JEFFERSON AND KENNEDY HIGH SCHOOL FIELD IMPROVEMENTS
9701 NICOLLET AVE
BLOOMINGTON, MN 55420

INDEPENDENT SCHOOL DISTRICT #271
1350 WEST 106TH STREET
BLOOMINGTON, MN 55431

FINISHING PLAN - KENNEDY

C3.01

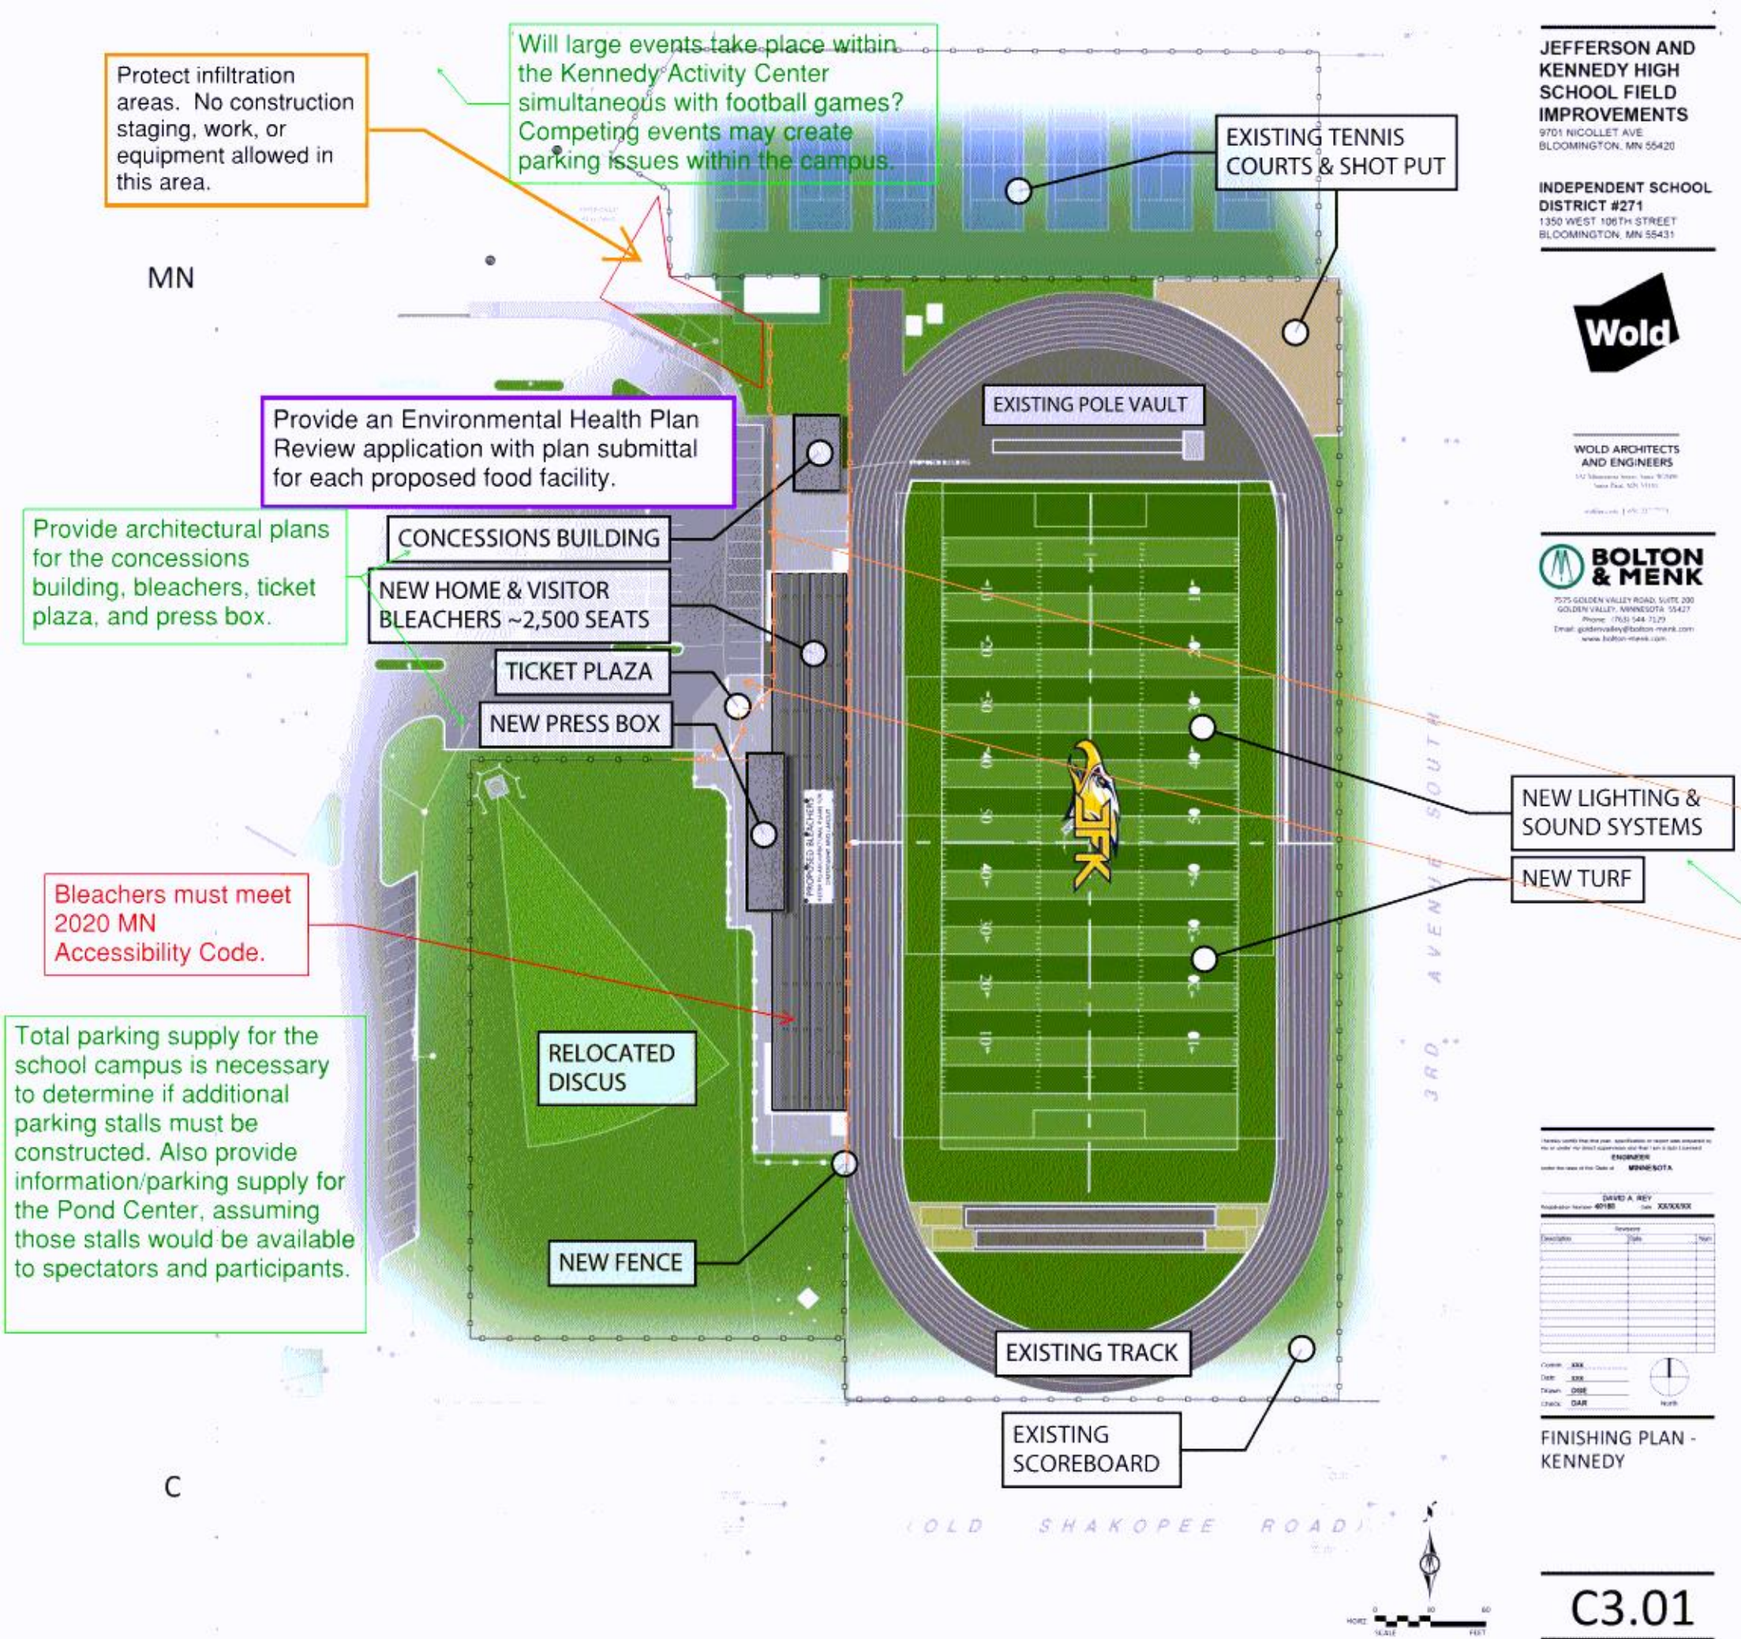
Must meet 2020 MN State Building Code

Building plans must be signed by a MN licensed architect.

SAC review by MET council will be required.

Must meet 2020 MN Accessibility Code.

Provide a detailed code analysis with the plans.

Refer to Table 1106.1 of 2020 MN Accessibility Code for required number of Accessible parking spaces.

Refer to Table 2902.1 of 2020 MN Building Code for minimum number of required plumbing fixtures.

Bleacher drawings shall be designed by a MN licensed Engineer.

Show plan for pedestrian access and queues outside of the drive areas. Use that plan to identify where sidewalk modifications are needed.

include ADA ped ramps for access from the ADA parking spaces/

show ped access and queuing for the ticket sales, outside of the parking lot

When available, please provide additional detail on the lighting and sound systems. With residential across the street, noise and light pollution are a concern.

The City must be able to determine MPCA and City noise limits are met. Levels are measure on the "receiving" side of the street - 3rd Avenue S. is the potentially the most impacted.
